TOWN OF GLASTONBURY
GL-2017-33
WELLES-TURNER MEMORIAL LIBRARY RENOVATIONS PHASE I
ADDENDUM NO. 3
May 12, 2017

REVISED Bid Due Date: 05-18-17 @ 11:00 A.M.

SK I5/A2.1
April 26, 2017

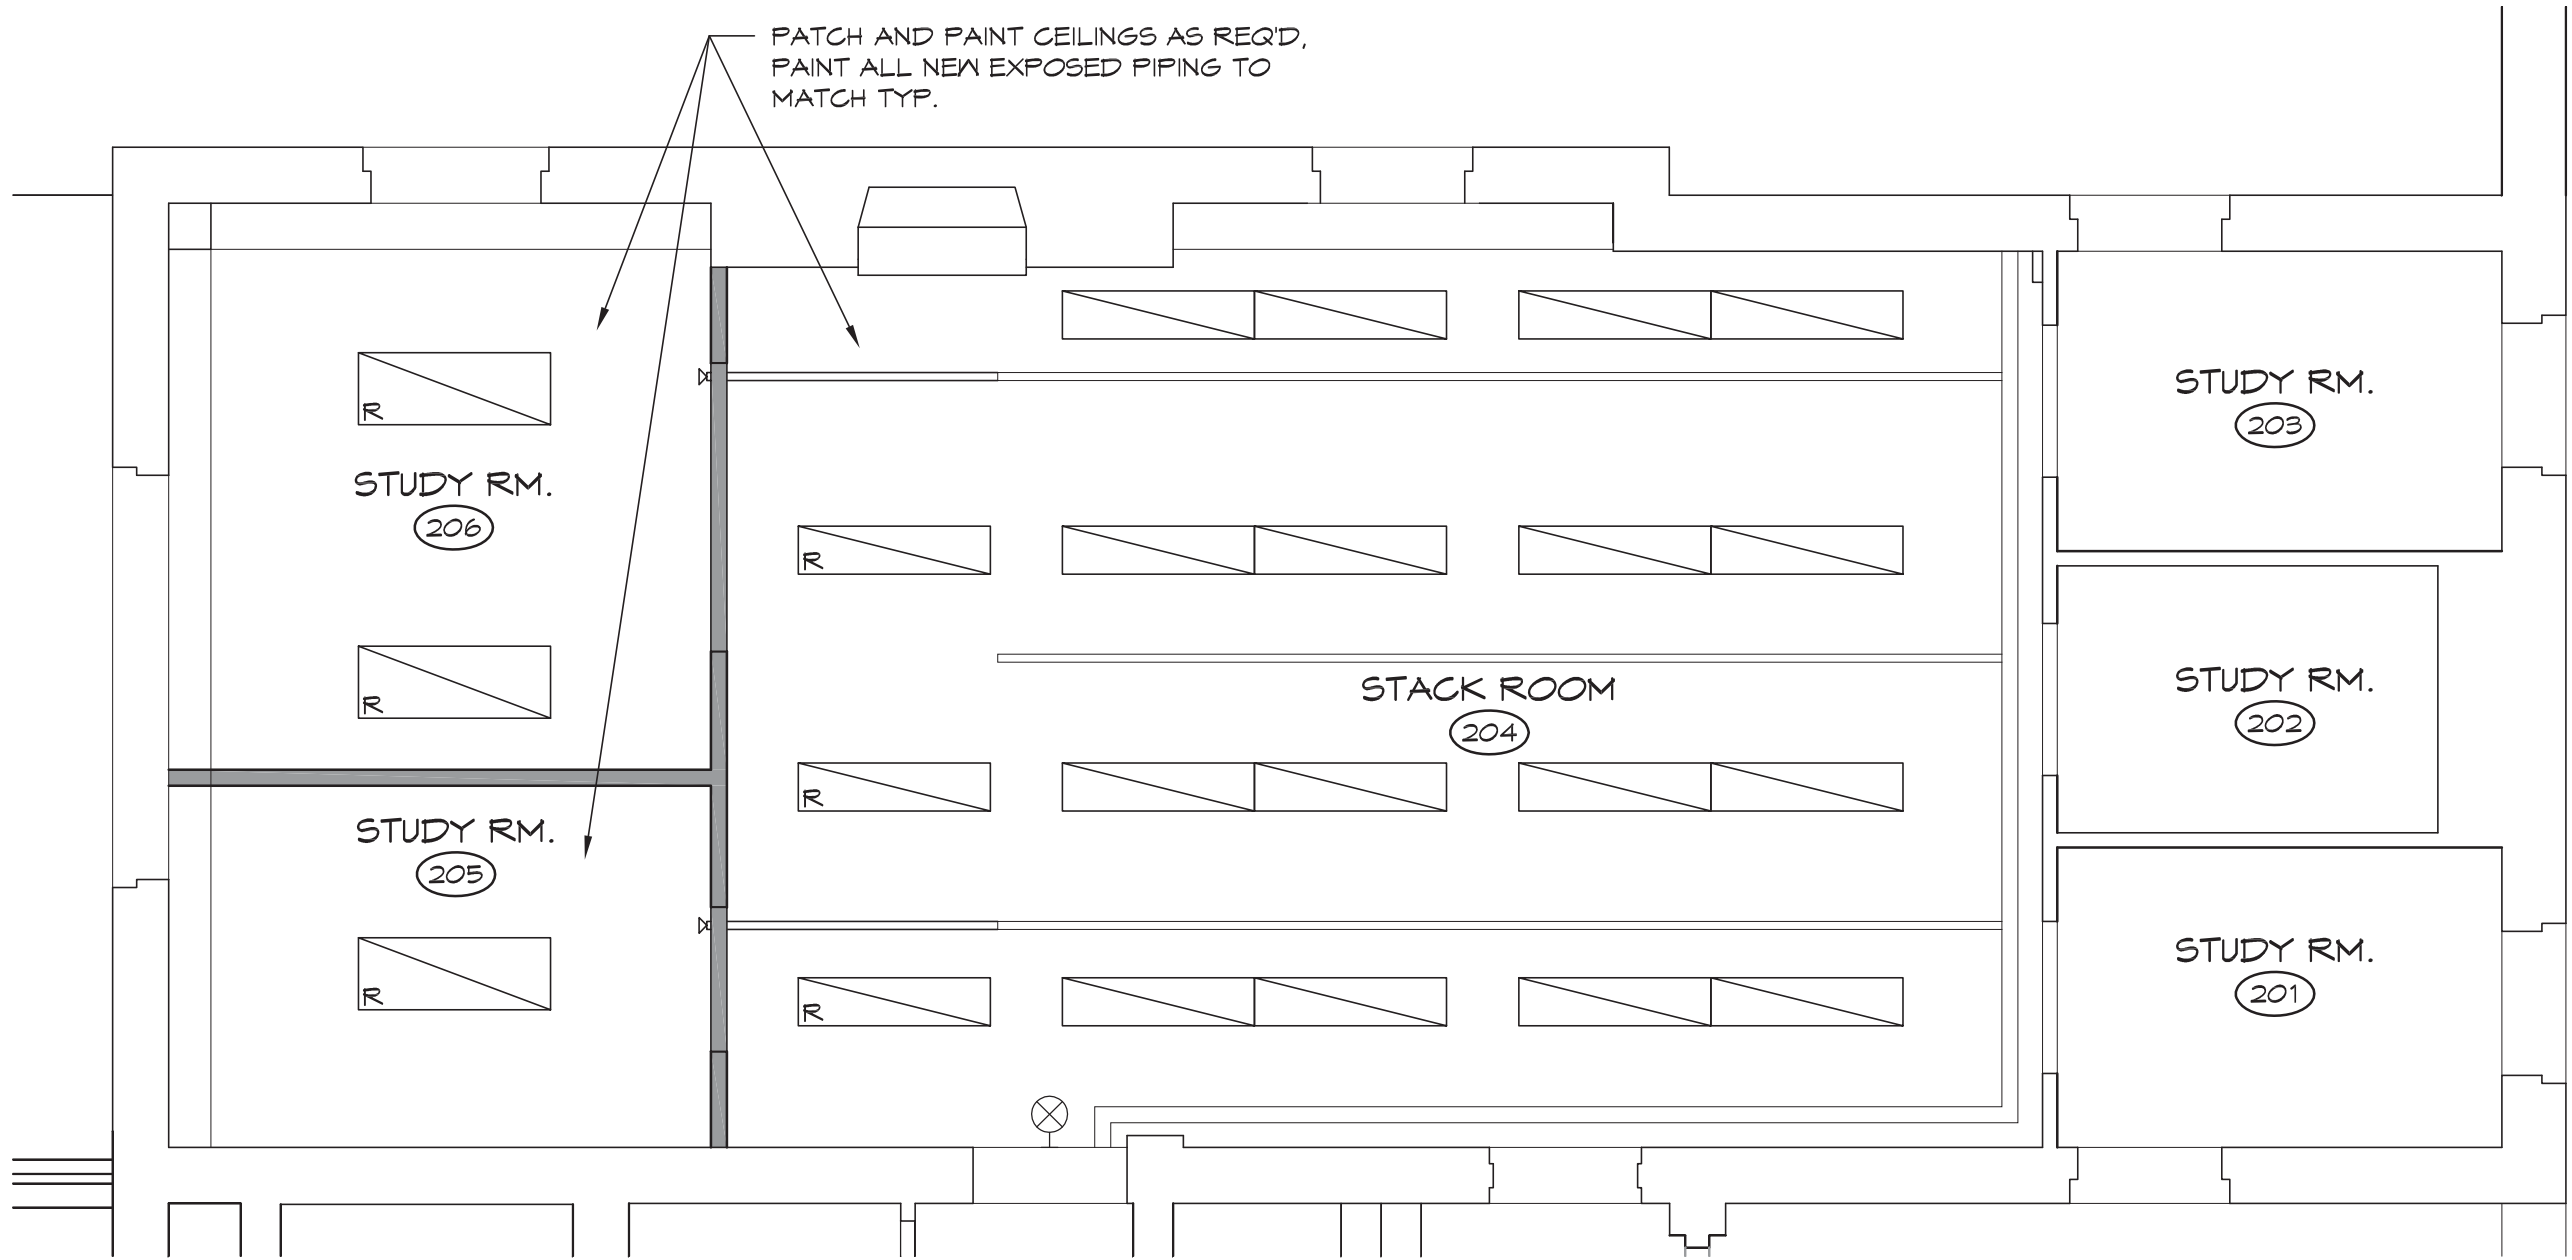
2. Drawings: Sheets AD1.1, A2.1, ED1.2 and EL1.2 – Clarification on relocated light fixtures at Main Floor work area: Per Demo Note 12 on Sheet AD1.1, remove, terminate and store (6) light fixtures for reinstallation, and (1) fixture to turn over to owner. [No change.] Reinstall (6) light fixtures as shown on Detail 15/A2.1. (Three wider fixtures in the two new study rooms; three narrower fixtures in central space.) [No change.] See attached sketch SK15/A2.1. Note: The Main Level demolition and electrical plans on Sheets ED1.2 and EL1.2 will be updated to reflect these conditions.
